Docket	:	<u>A.25-06-017</u>
Exhibit Number	:	<u>CA-07</u>
Commissioner	:	<u>M. Baker</u>
Admin Law Judge	:	<u>R. Haga</u>
Witness	:	<u>C. Madison</u>

PUBLIC ADVOCATES OFFICE
CALIFORNIA PUBLIC UTILITIES COMMISSION

**TESTIMONY ON
OPERATIONS
FOR MOUNTAIN VIEW FIRE
COST-RECOVERY APPLICATION**

Reasonableness of Operations Prior to Ignitions

7 **Figure 1:⁶²**
8 **Results of 2020 Asset Survey: Topaz 1261 Circuit**

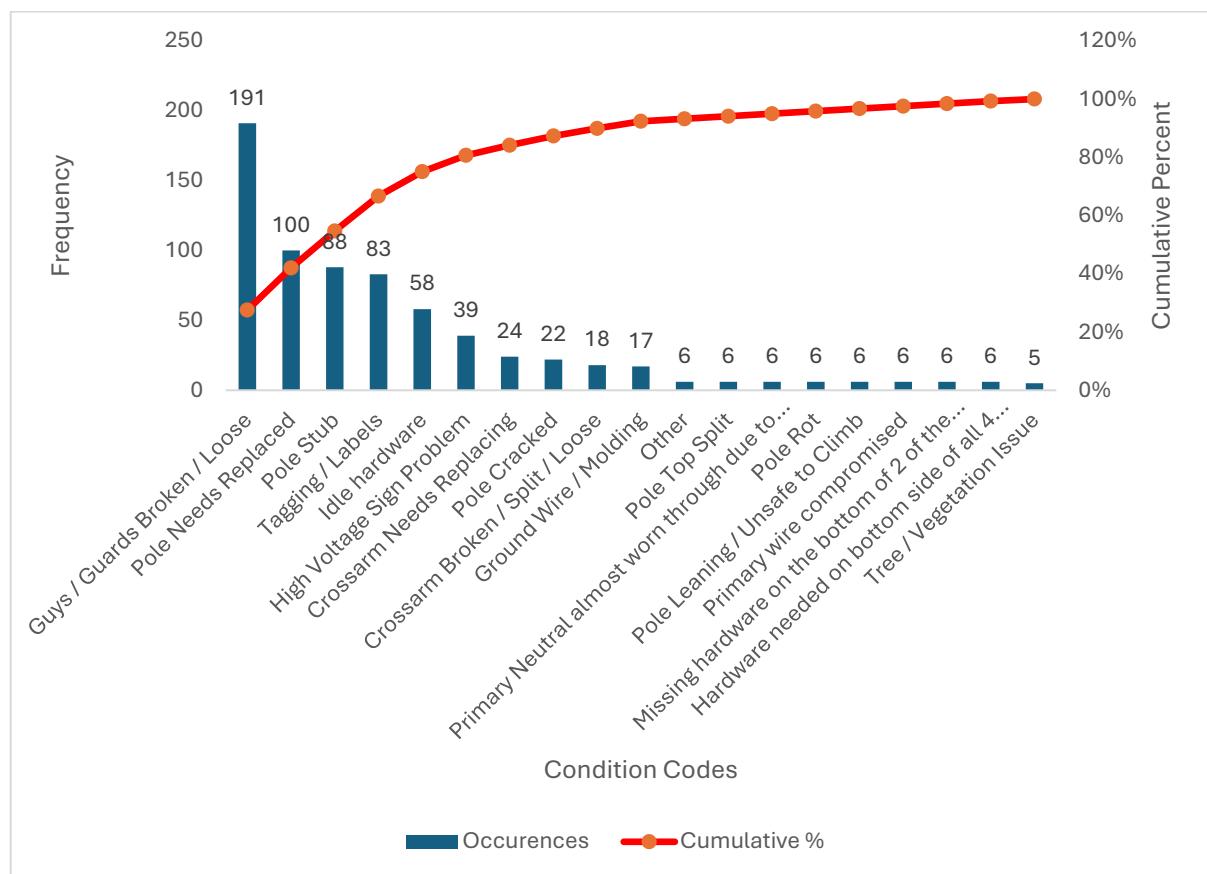
4 The condition code data makes the pattern unmistakable. Figure 1 shows the
5 conditions identified on Topaz 1261 circuit during its 2020 Asset Survey, organized from
6 most to least common.

10 Figure 1 also illustrates that the Topaz circuit's condition issues were highly
11 concentrated in a small number of defect categories, several of which are associated with
12 direct reliability or safety risk. The fact that more than half of all observed defects fall

Figure 2:
Late 2020 Asset Survey Corrections

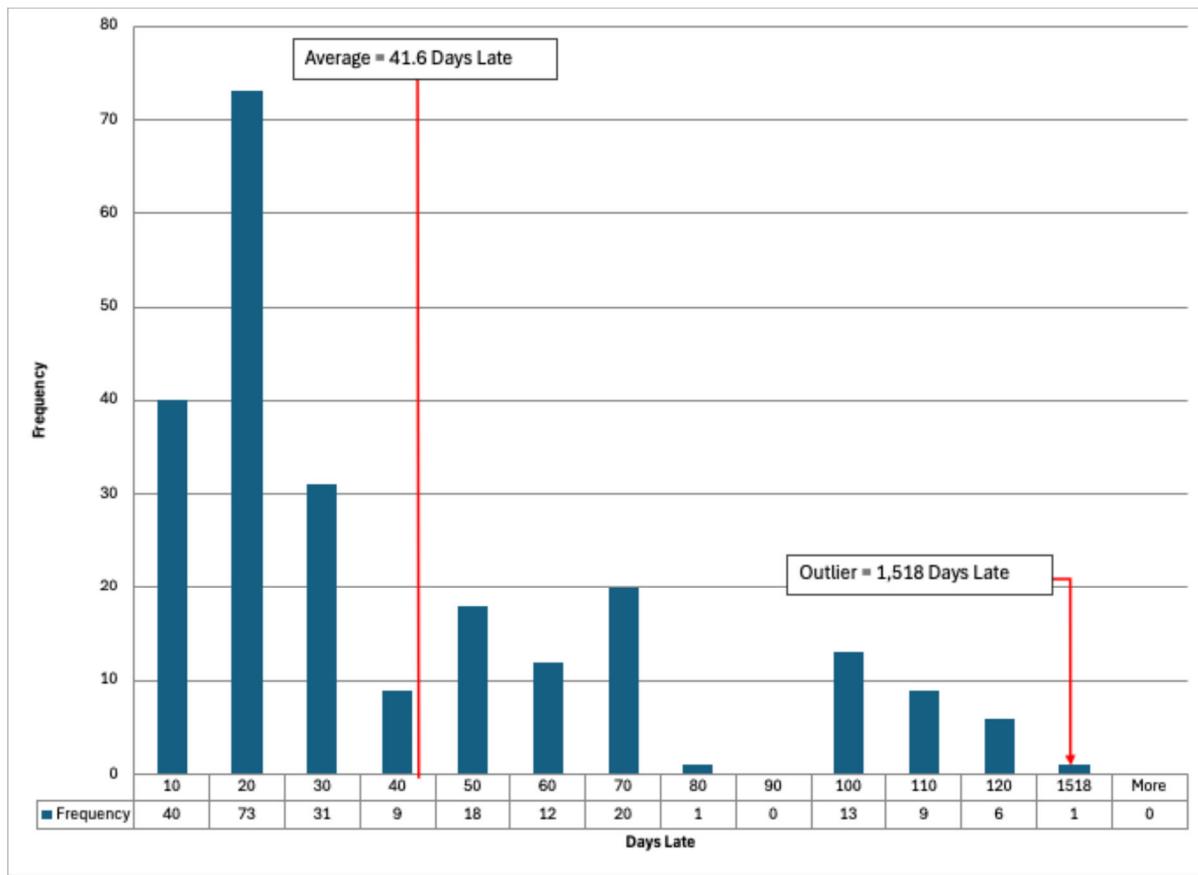
8 Figure 2 shows a frequency distribution of late completions. The chart reveals that
9 the majority of items fall within the 10- to 40-day late range, with the highest
10 concentration around 20 days late. The vertical red line marks the average lateness of
11 41.6 days.⁷⁴ The most striking of these is the extreme outlier at 1,518 days late, which is
12 called out separately on the chart.
